Planning Commission
Staff Report
July 30, 2018

Case No:	17zone1017
Project Name:	Circle K
Location:	9201-9211 Preston Hwy. & 4600 E. Manslick Rd.
Owner(s):	Scott Whitaker/Chester Jenkins
Applicant:	Mac's Convenience Stores LLC
Jurisdiction:	Louisville Metro
Council District:	24- Madonna Flood
Case Manager:	Julia Williams, RLA, AICP, Planning Supervisor

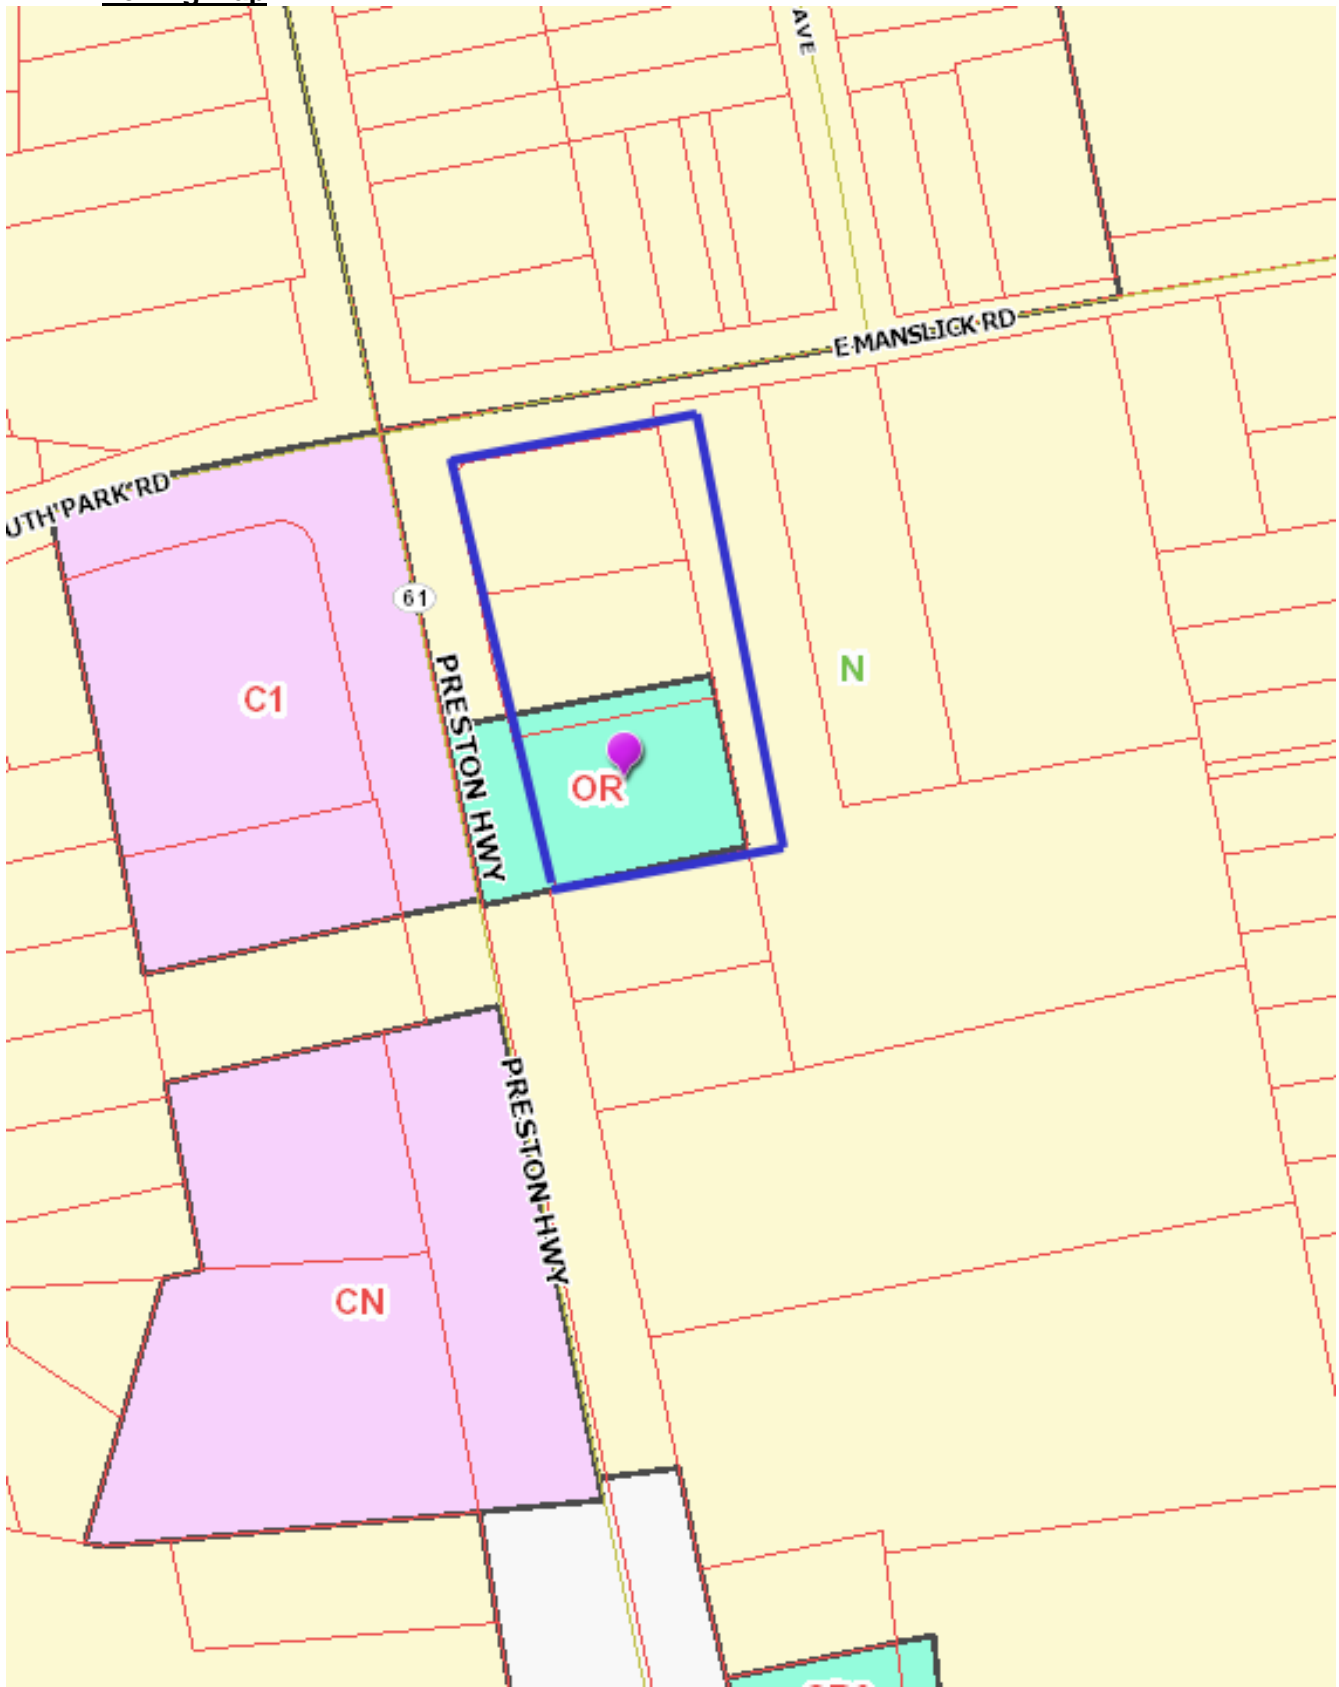
- The applicant needs to remove the pavement on the plan and add a note that future connectivity will be made upon redevelopment of the adjacent site.
- MSD and Transportation have given preliminary approvals
